KPD-TAY COMPRESSION PROJECT
Tender Enquiry No.: PROC/FC/PROJ/KPD-TAY/COMP/5313/2022
PRE-BID CLARIFICATION # 04

One of the bidder has asked following queries, OGDCL/ENAR's response is as follows:

WATER ANALYSIS REPORT

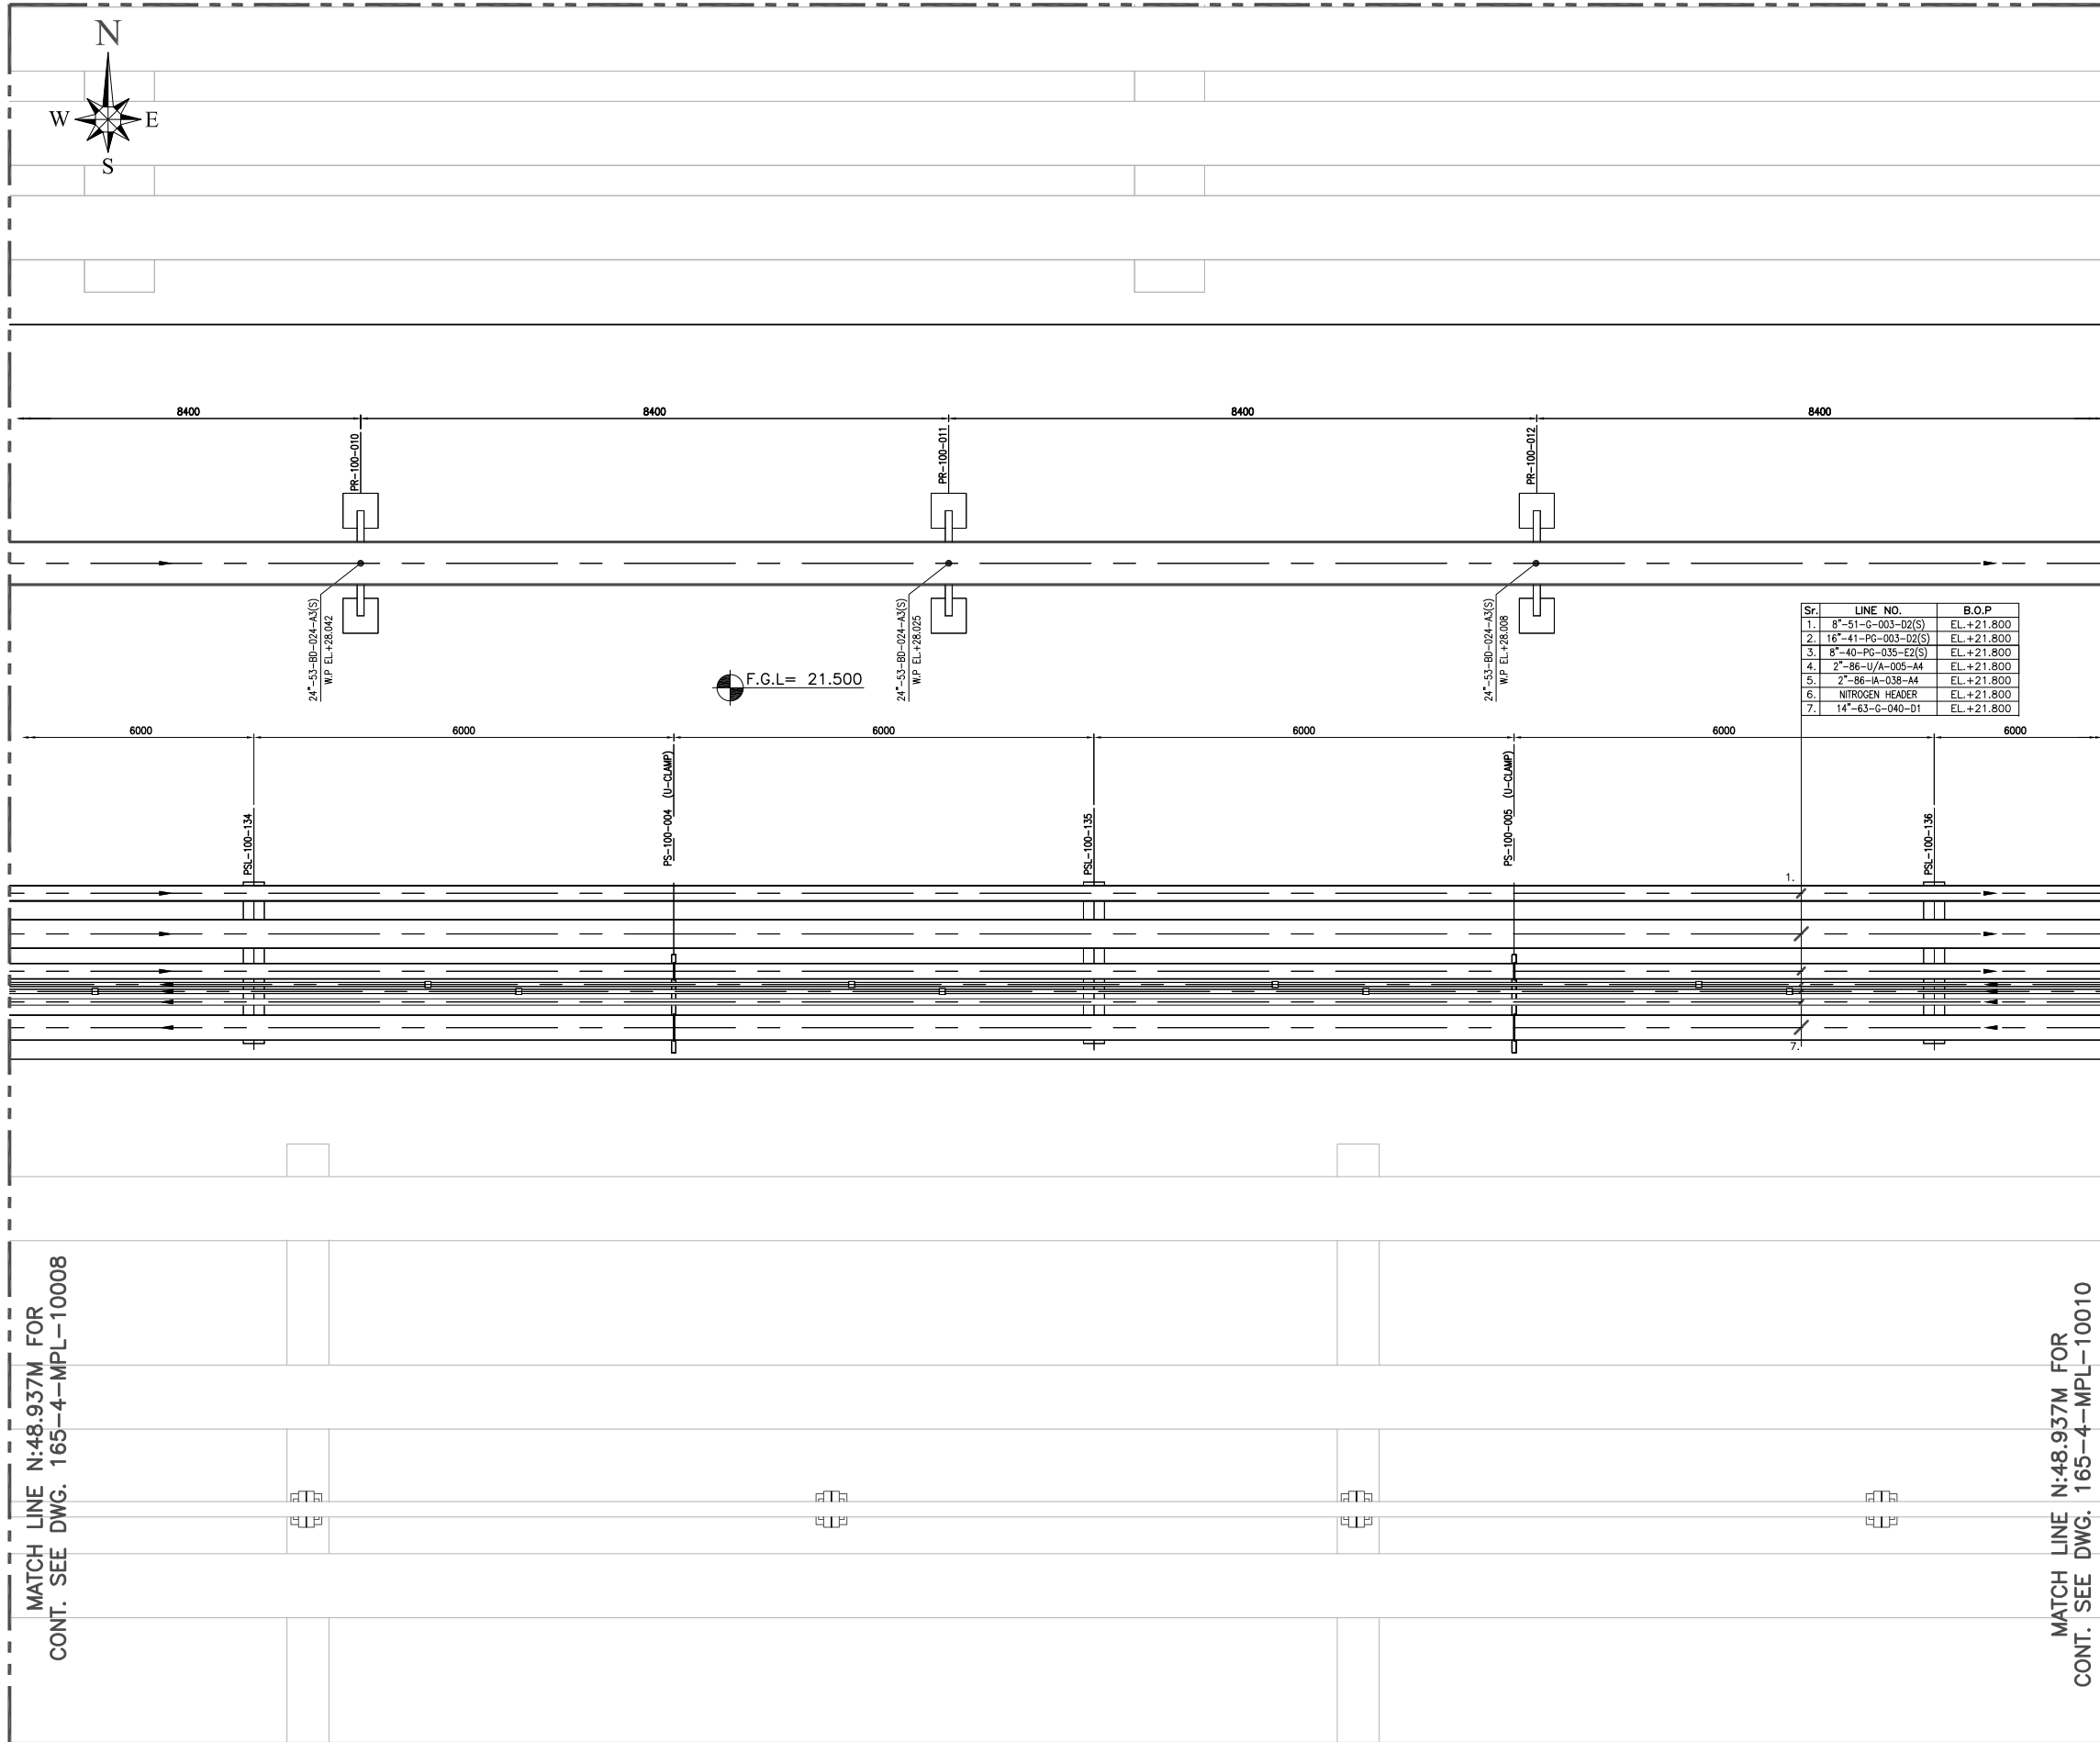
| Sr. No. | Tender Document Reference | Clarification By Bidder | OGDCL / ENAR's Response |
|---------|--|--|---|
| 4 | Volume-II1- Volume-IIA (Process)\6-Datasheets\0258-DS-1051-0 (Bore Water Filters F-5601AB); 0258-DS-1055-0 (Bore Water Filters F-5801AB) | Please provide raw water quality information for the selection of sand filters. | Please find raw water analysis in Attachment-I . |

DWG. NO. **165-4-MPL-10009**

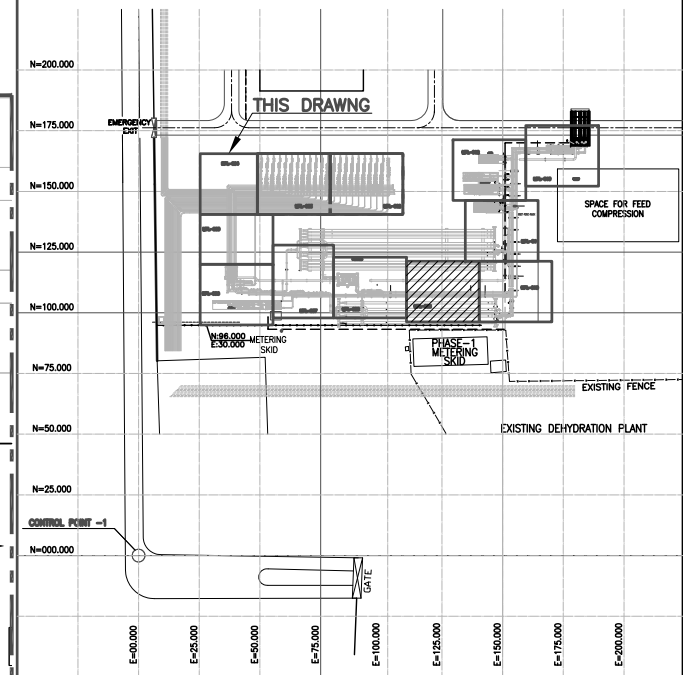
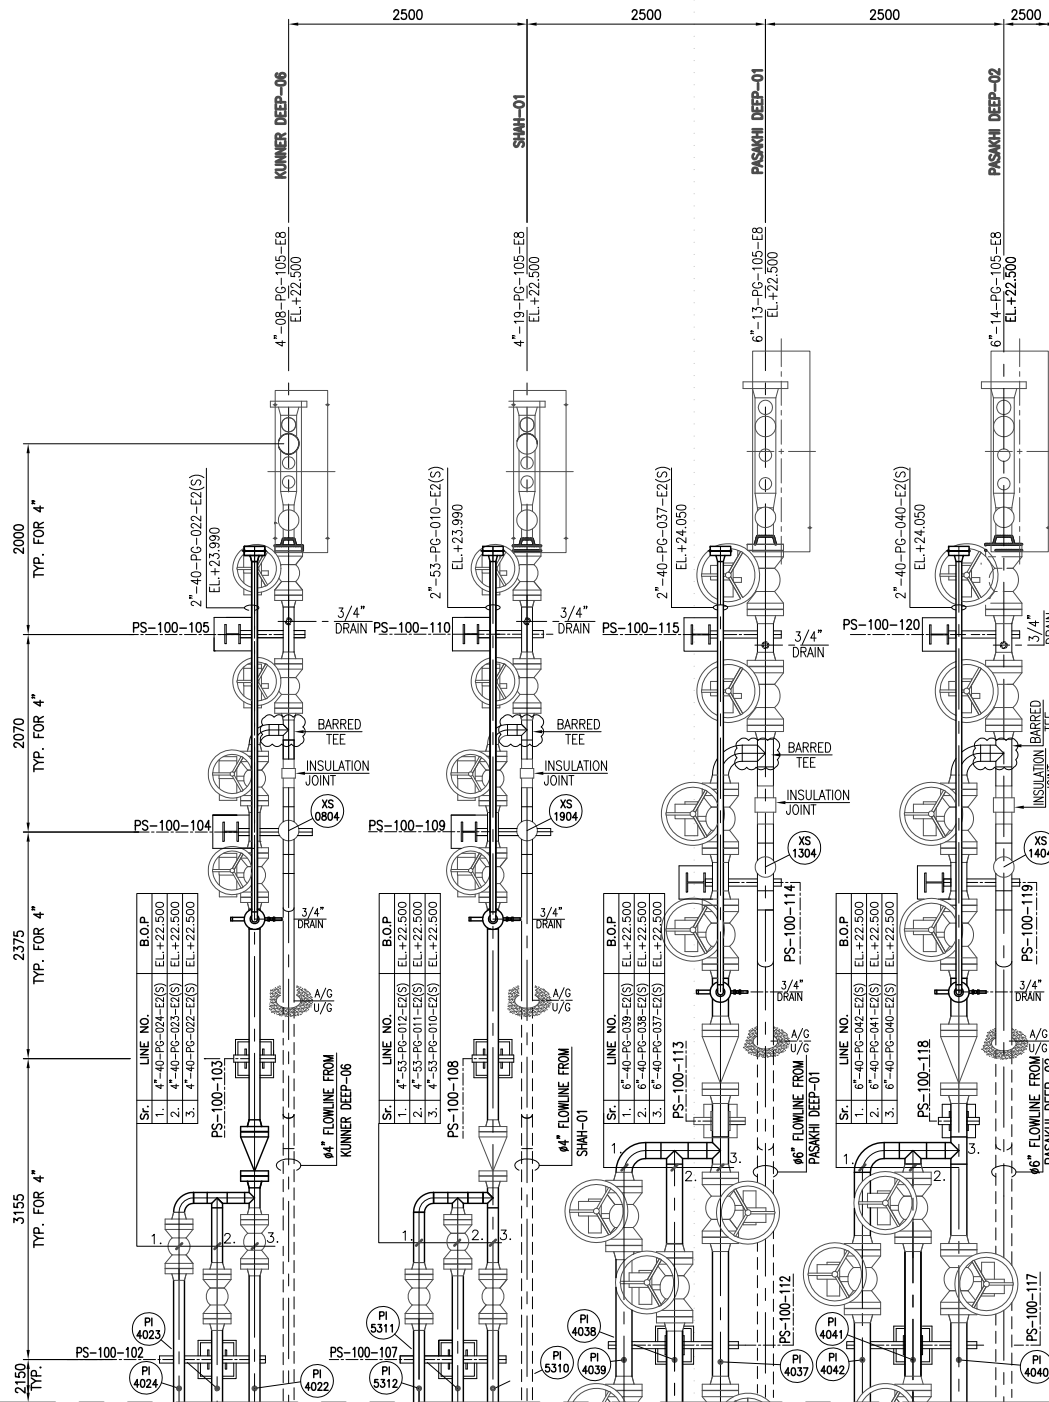
| Sr. No. | Tender Document Reference | Clarification By Bidder | OGDCL / ENAR's Response |
|---------|--|--|---|
| 6 | Volume-II2- Volume-IIB (Mechanical)\Piping Layouts | We found that piping layouts (165-4-MPL-10009, 10014, 10019, 10020-R-F2) are missing. Please provide. | These piping layouts are not used for the conceptual piping of KPD-TAY Compression Project. For clarity, these piping layouts are attached as Attachment-II . |
